PENRITH CITY COUNCIL

MAJOR ASSESSMENT REPORT

Application number:	DA20/0229
Proposed development:	Demolition of Existing Structures & Construction of Part Two (2) Storey & Part Three (3) Storey Seniors Housing Development comprising Three (3) Buildings including 33 Independent Living Units, Related Communal Facilities, Basement Car Parking & Associated Site Works
Property address:	162 Stafford Street, PENRITH NSW 2750 160 Stafford Street, PENRITH NSW 2750 156 Stafford Street, PENRITH NSW 2750 154 Stafford Street, PENRITH NSW 2750
Property description:	Lot 1 DP 20976 Lot 2 DP 20976 Lot A DP 405051 Lot 1 DP 25705
Date received:	1 May 2020
Assessing officer	Sandra Fagan
Zoning:	SEPP WSA - Affected by Obstacle Limitation SEPP WSA - Affected by Wildlife Buffer Zone Zone R3 Medium Density Residential - LEP 2010
Class of building:	Class 2 , Class 7a
Recommendations:	Approve

CEILING HEIGHT NON-COMPLIANCE

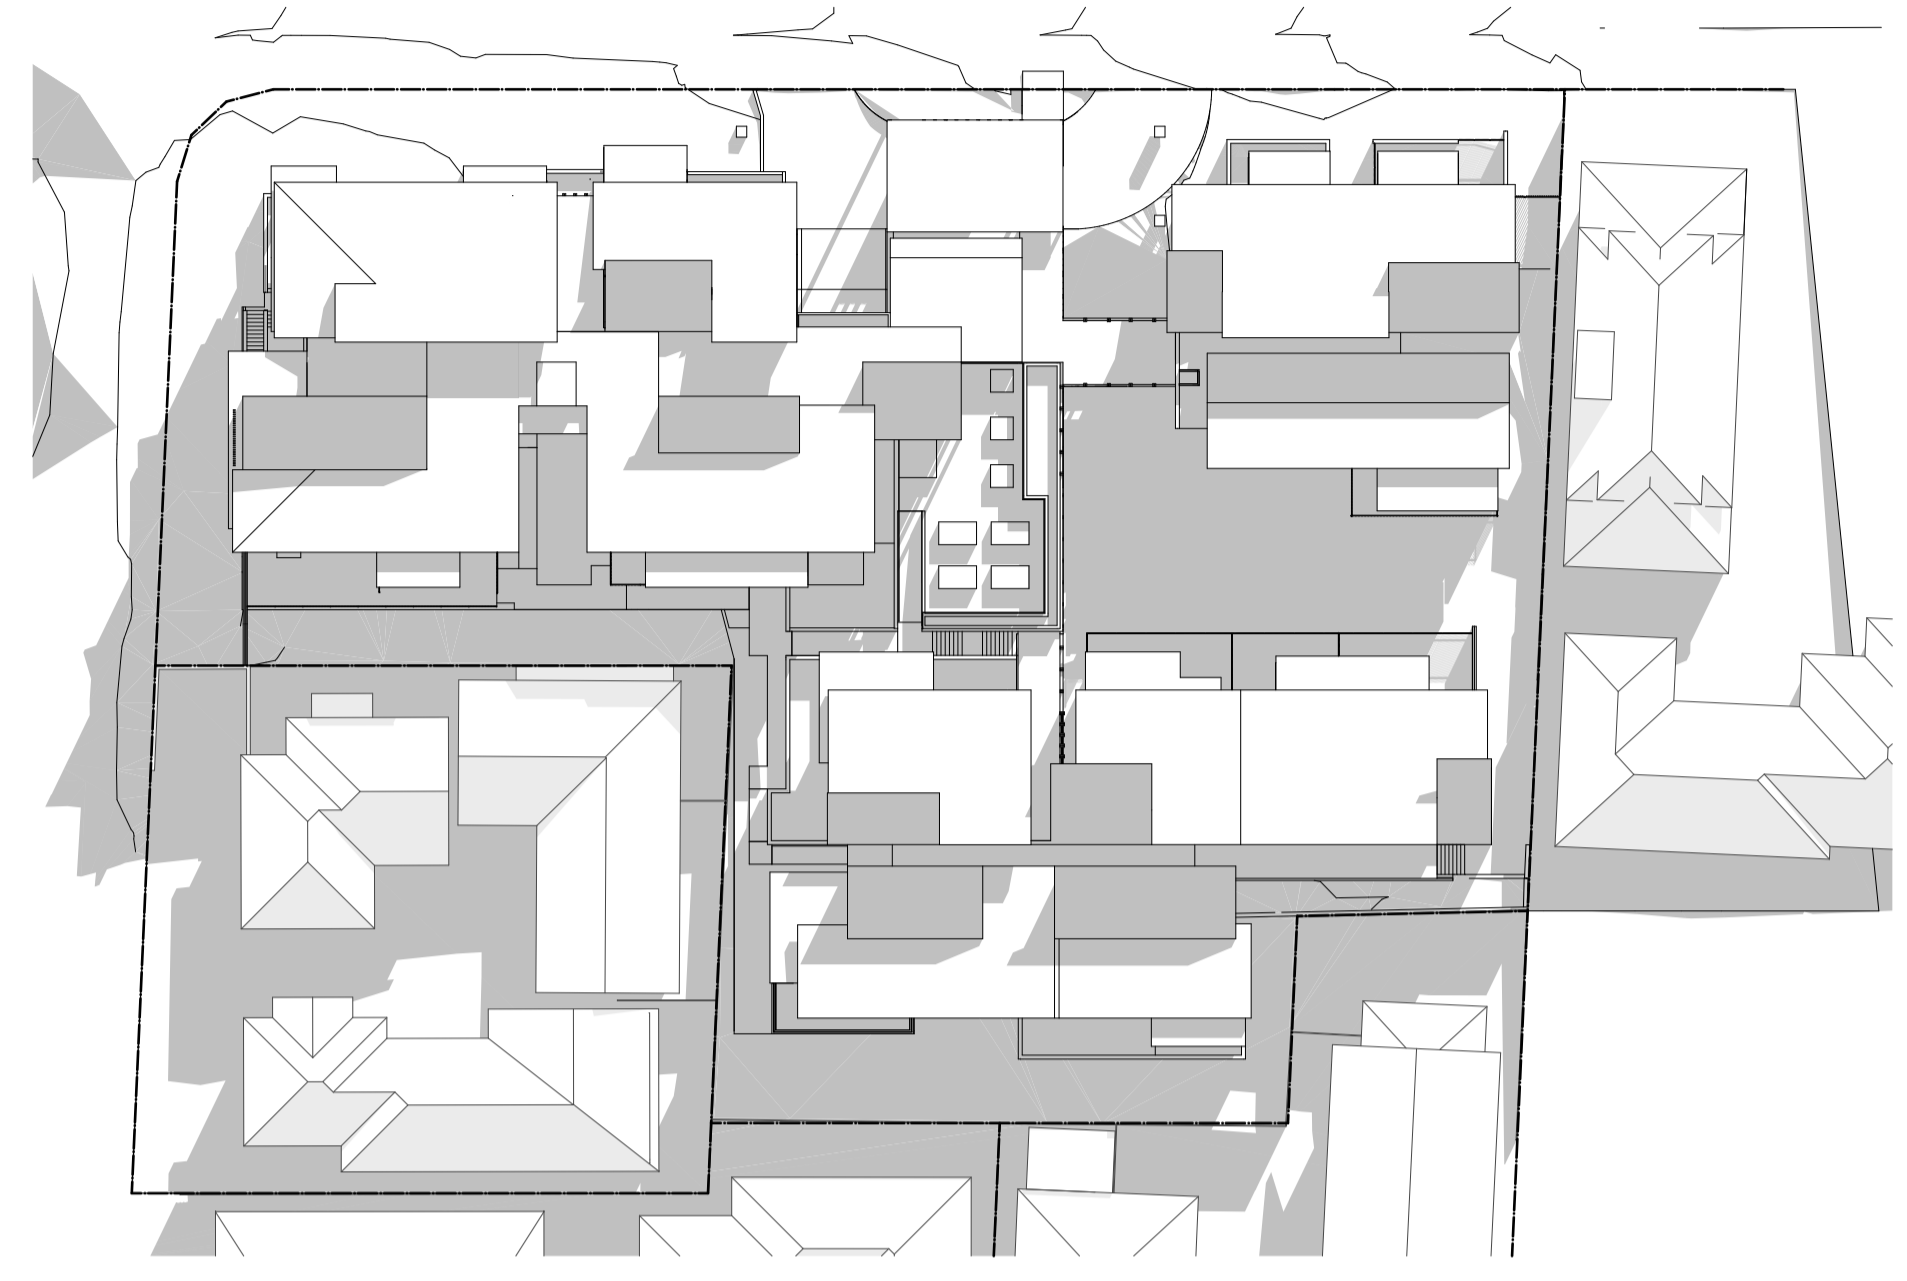
However, because of the raked ceiling design used in parts of the buildings, some areas on the top floor exceed the SEPP height control of 8 metres (with the SEPP height measured to the **ceiling**). The numerical non-compliance ranges from 0.5m to 2.14m over the control representing a non-compliance of between 6.26% to 26.75%. It is for this reason that the Development Application is to be determined by the Local Planning Panel. In accordance with Planning Circular PS18-003 issued on 21 February 2018, the Local Planning Panel have the assumed concurrence of the Planning Secretary to determine the application as the proposed development will contravene the standard by more than 10%.

Further, the Penrith Local Environmental Plan (LEP) allows height of 8.5 metres (with the LEP height measured to the top of the building). Again because of the raked ceiling design the top of some areas of the development will exceed this control. While it is acknowledged that the LEP allows a higher maximum height, albeit measured differently, the height control of 8 metres contained in the SEPP will take precedence as the SEPP is the higher order planning document. Nevertheless the numerical non-compliance ranges from 0.4m to 2.21m over the control, representing a non-compliance of between 4.7% to 26%.

The Development Application includes a written request to seek to allow variation of the height controls in both the SEPP and LEP, made pursuant to Clause 4.6 of the LEP. In addition, the architectural drawings include a floor plan showing specifically in plan where the height breaches will occur (Drawing number DA-A-804) and a 'Height Blanket Diagram' showing in 3D the specific parts of the building which will breach the height controls (Drawing number DA-A-901).

Yes, it is considered that the applicant's request outlined above follows a sound line of argument for justifying why the height control is unreasonable or unnecessary in this particular case. The statement has also outlined what environmental planning grounds they consider relevant for allowing a contravention of the development standard. Therefore, it is considered that the written request is sound and has addressed the relevant matters required by Clause 4.6(3).

SEPP 8m ceiling height
HEIGHT BLANKET DIAGRAM

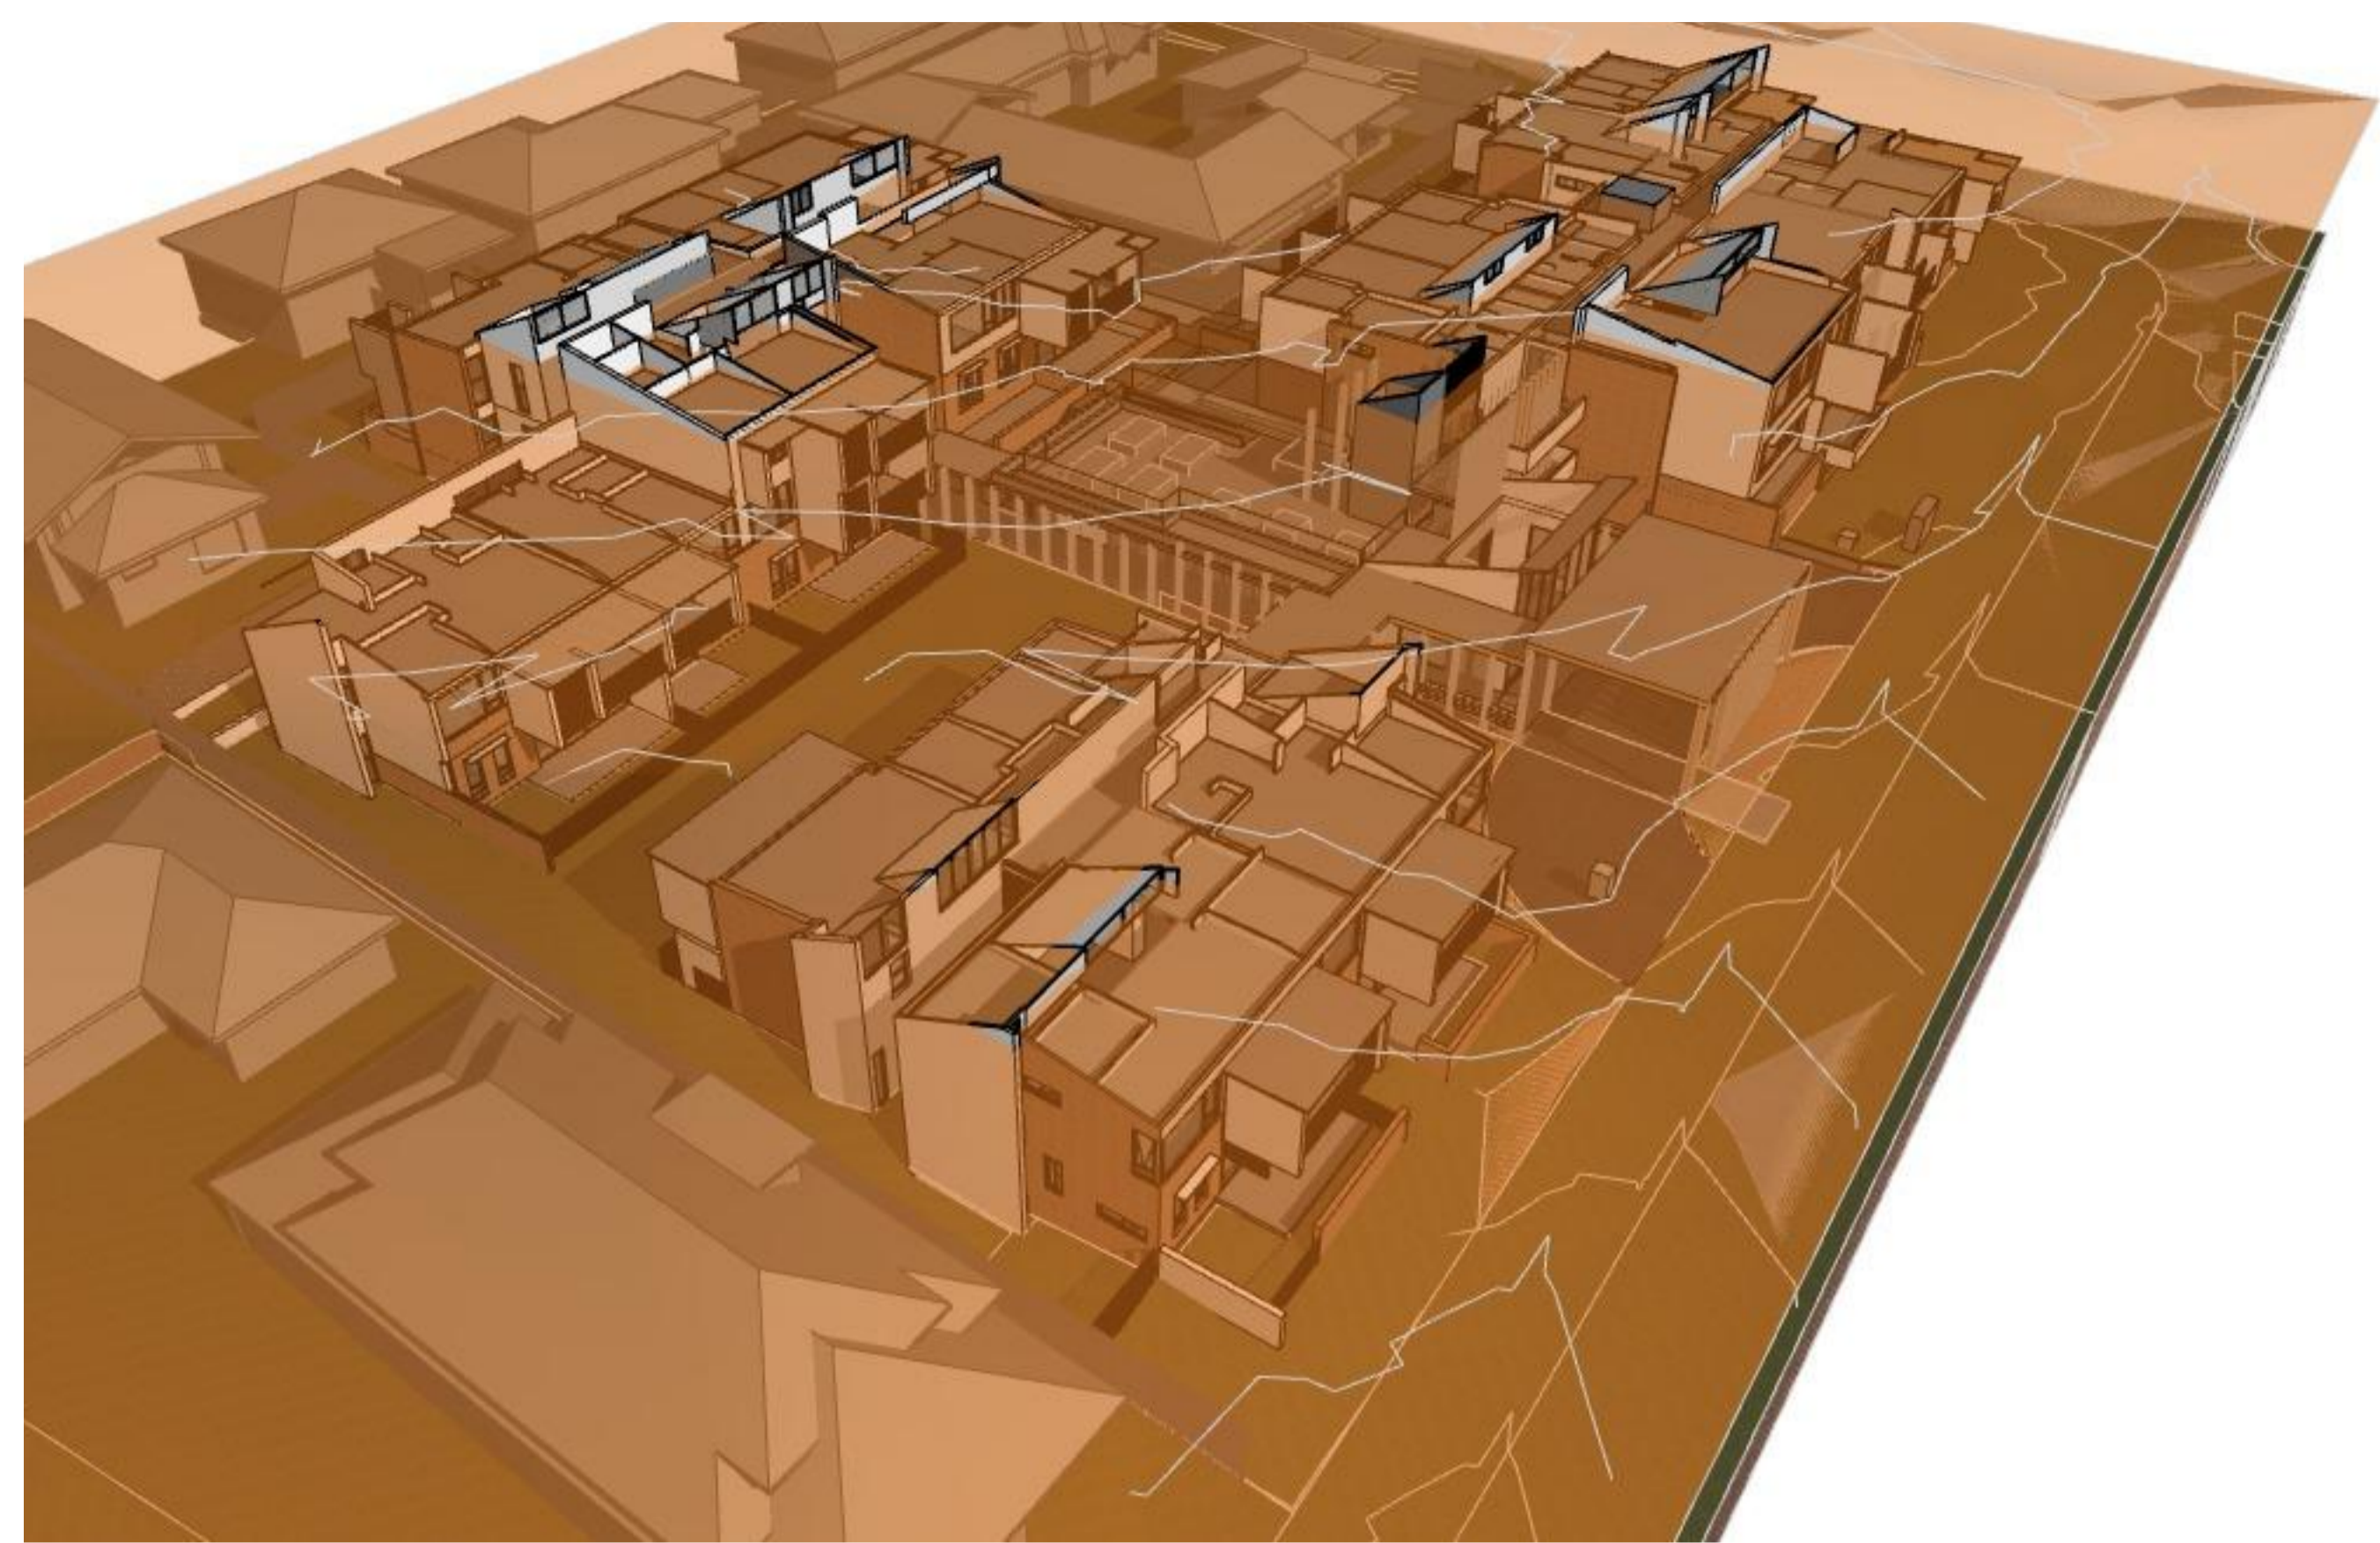
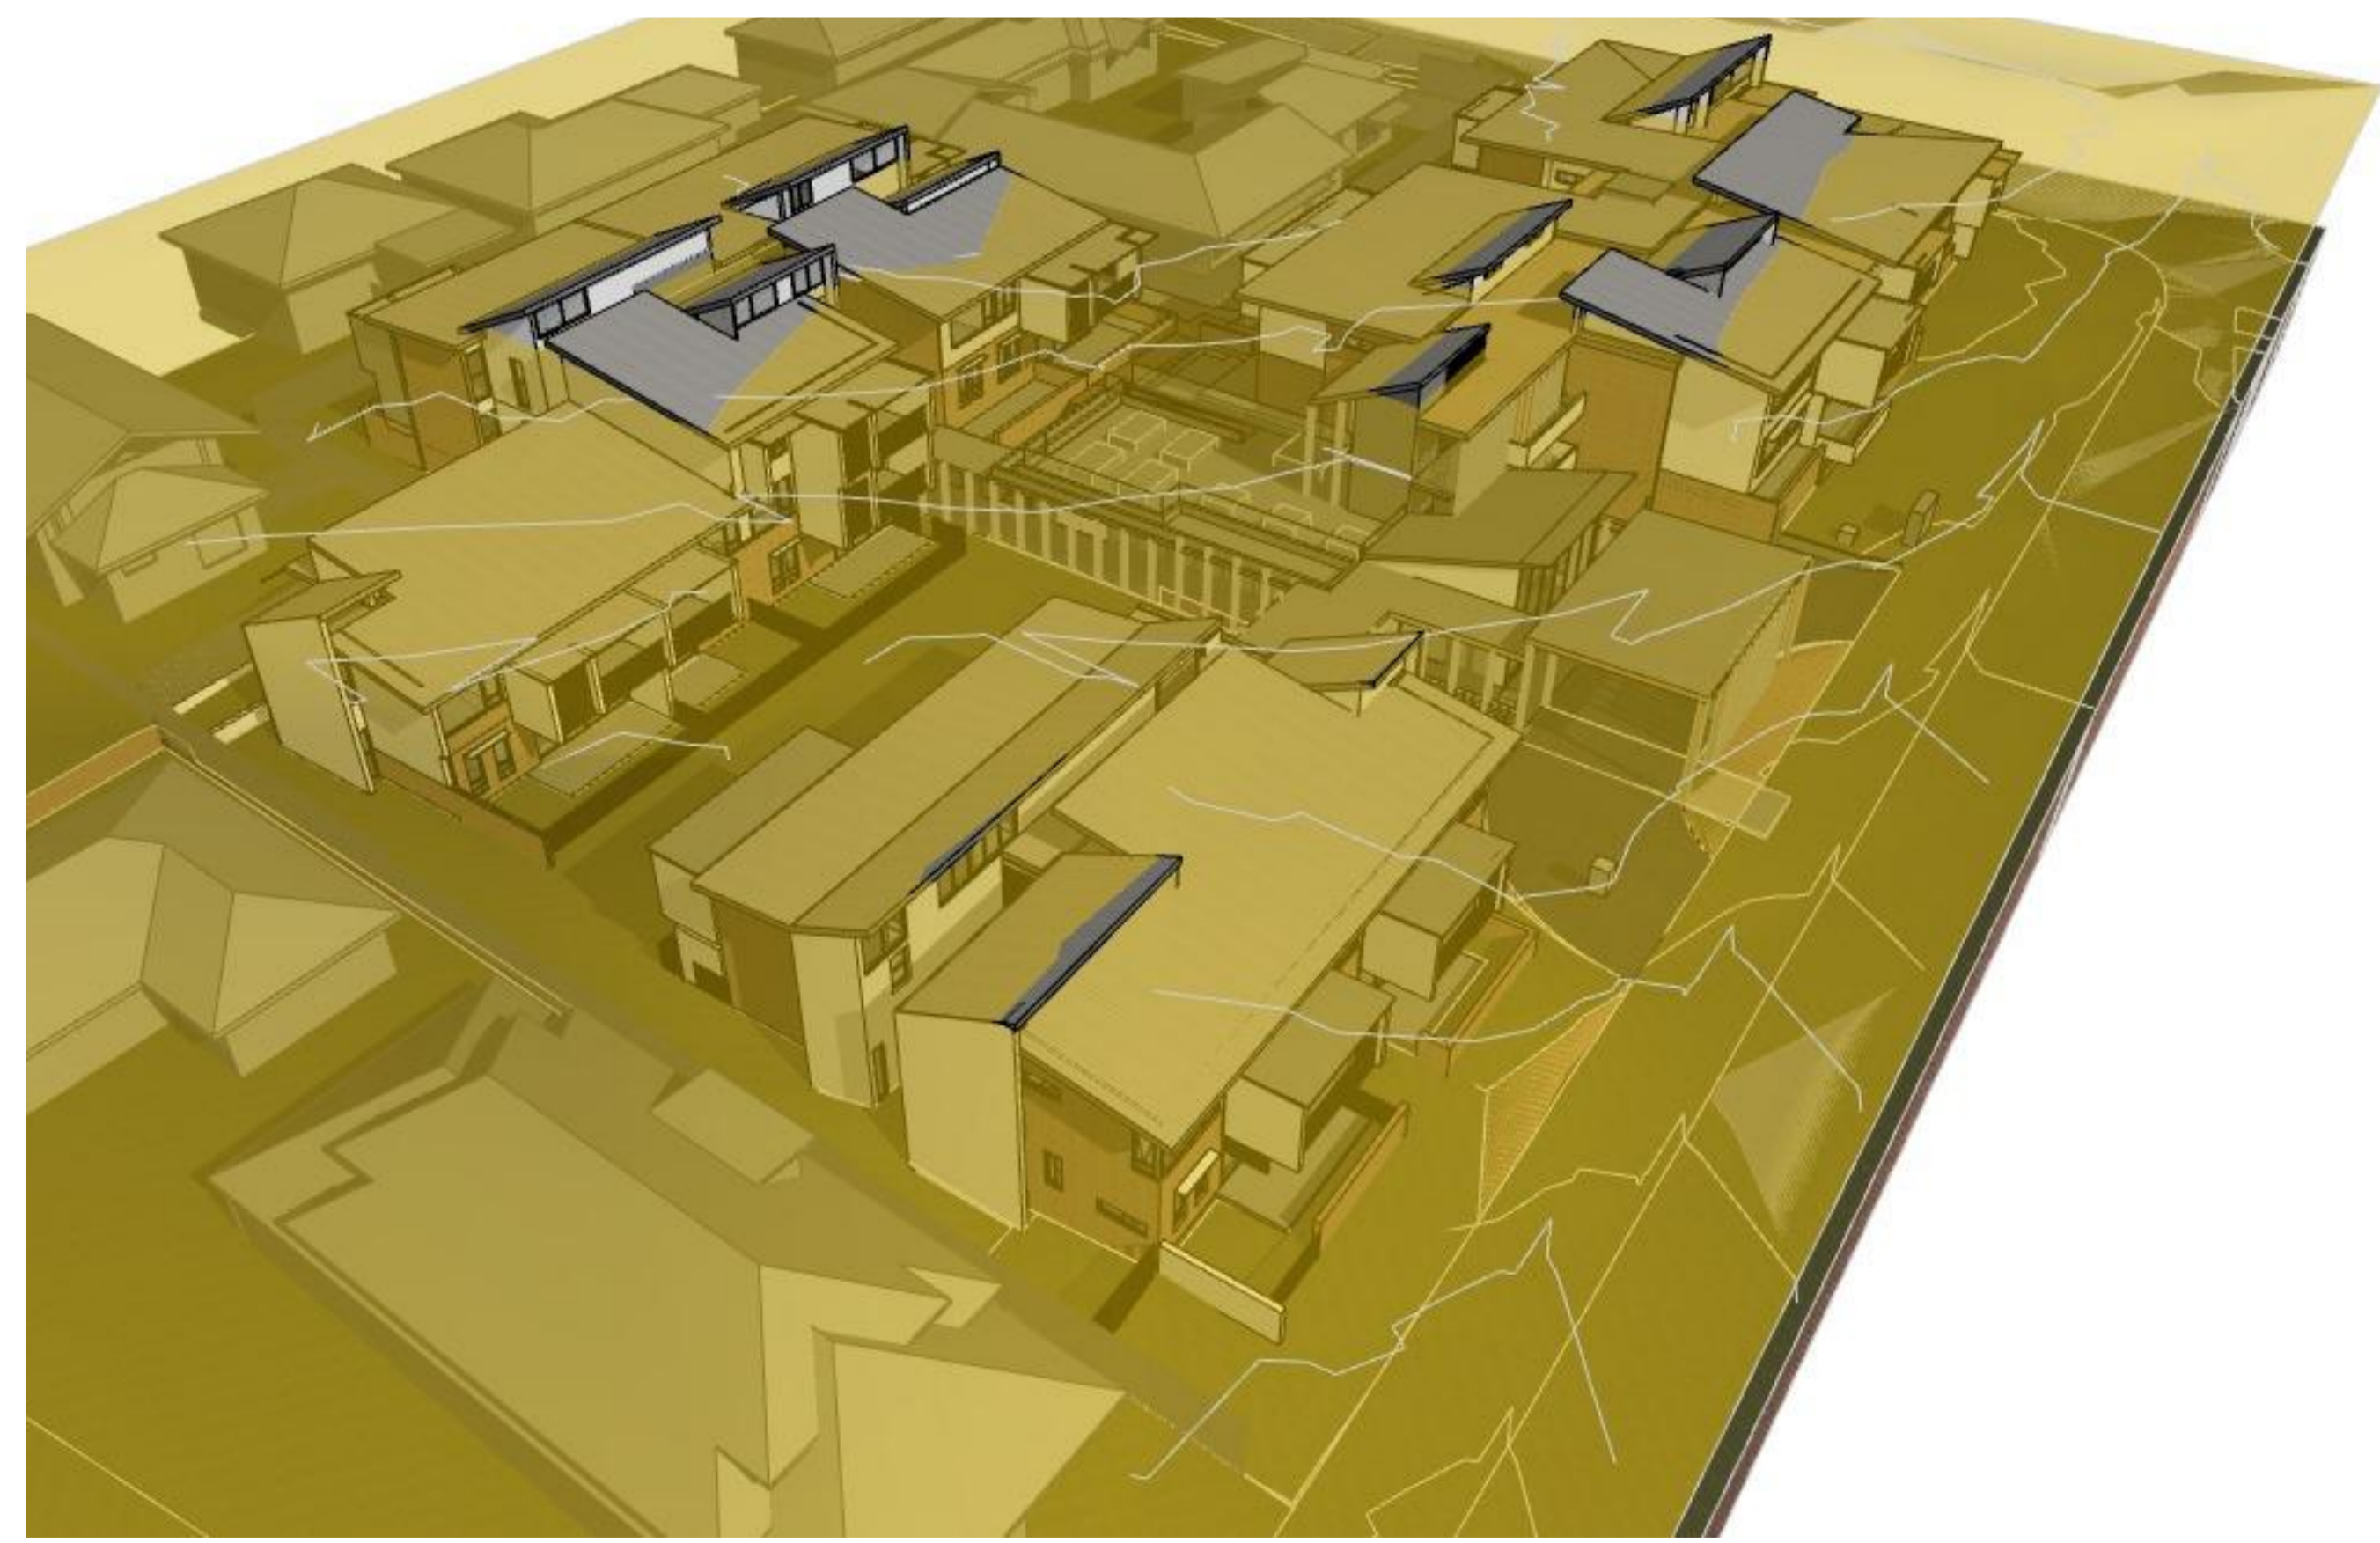
As indicated in the sections in Figure 3 and 3, the maximum building height pursuant to the definition contained within the SEPP (from ground to upper floor ceiling height) is 10.14m at building C and this occurs only because of clerestory roof elements that provide natural light and improved amenity for the nominated dwellings. This is a maximum variation of the SEPP 8m height of 2.14m (26.75%).

Although the building height provision of the SEPP overrides the local height provision prescribed by PLEP 2010, in the interests of abundant caution, this variation request also considers variation to the LEP height limit. The maximum height pursuant to PLEP 2010 (from ground level to roof ridge) is 10.71m at Building C. This is a variation of the 8.5m PLEP 2010 height of 2.21m (26%). This is visual represented in Figure 2.

Provided in Figures 1 and 2 over page are height blanket diagrams for the proposed SEPP and LEP height variations. These diagrams demonstrate not only the proposed encroachments but also the substantial amount of the buildings that will be compliant with the relevant height limit.
